Scott G. Fitzwilliams, Forest Supervisor
White River National Forest
900 Grand Avenue
Glenwood Springs, CO 81601

Submitted to: <https://cara.ecosystem-management.org/Public/CommentInput?Project=54909>
Comment letter ID is 54909-2733-11

RE: Proposed 2019 Copper Mountain Snowmaking and Summer Uses Projects

Far East Lot as currently developed adjacent to the CDNST travel route

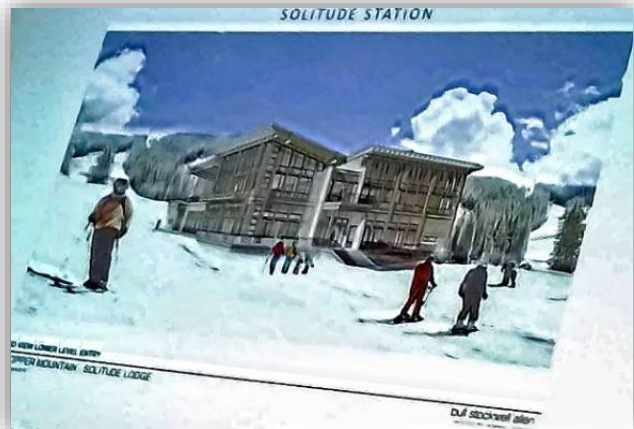
The revised scoping notice should specifically seek public comments on the proposed action to expand the Corn Lot in 2019. The 2008 CMR Tenmile Creek Facilities Improvements and Restoration Project EA decision fails to recognize and protect the *nature and purposes*¹ of the CDNST. An updated Master Development Plan, and current and future NEPA processes, must recognize the significance of the CDNST as it passes through the CMR Special Use Permit area. I am specifically concerned with scenery effects of the Far East Parking Lot (aka Corn Lot) on CDNST values. The effects on CDNST values of the Restoration Project EA decision of 2008 should be mitigated by applying visual screening best management practices. Further development of the Far East Lot should be suspended and no permit issued or operating plan

approved for expansion of the lot until the CMR Master Development Plan is amended and the 2006 CMR Trails and Facilities Improvement EIS and the 2008 CMR Tenmile Creek Facilities Improvements and Restoration Project EA are supplemented to address the requirements of the National Trails System Act as implemented through the direction in the 2009 CDNST Comprehensive Plan, FSM 2353.4, FSH 1909.12 part 24.43, and Federal Register Notice of final amendments to the CDNST Comprehensive Plan and final directive (74 FR 51116). The CDNST Comprehensive Plan is attached for reference (**Attachment A**).
